# APPROVED MINUTES

## February 18, 2021 Standards Committee Meeting

RE: Minutes from the February 18, 2021 Standards Committee Meeting

E 801-TCTC-10 MAINTENANCE OF TRAFFIC FOR RPM REFLECTOR REPLACEMENT (WITH MARKUPS)

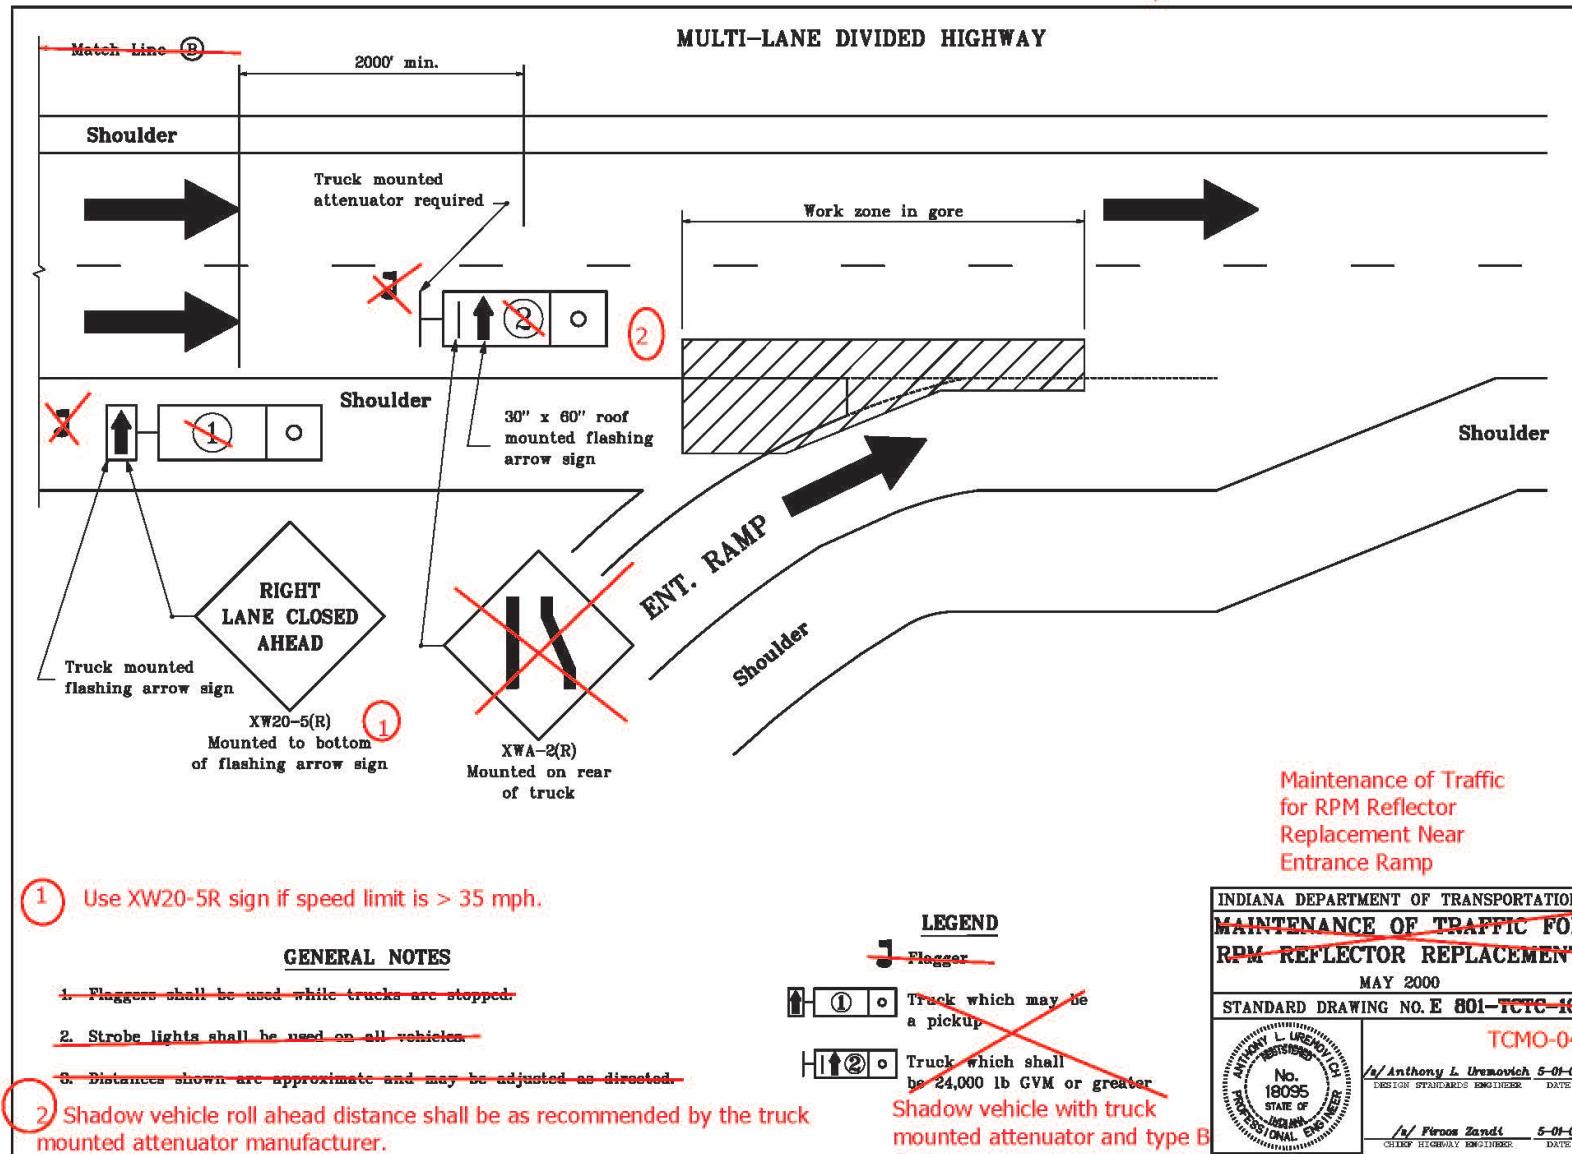
Move to new series on Traffic Control for Mobile Operations
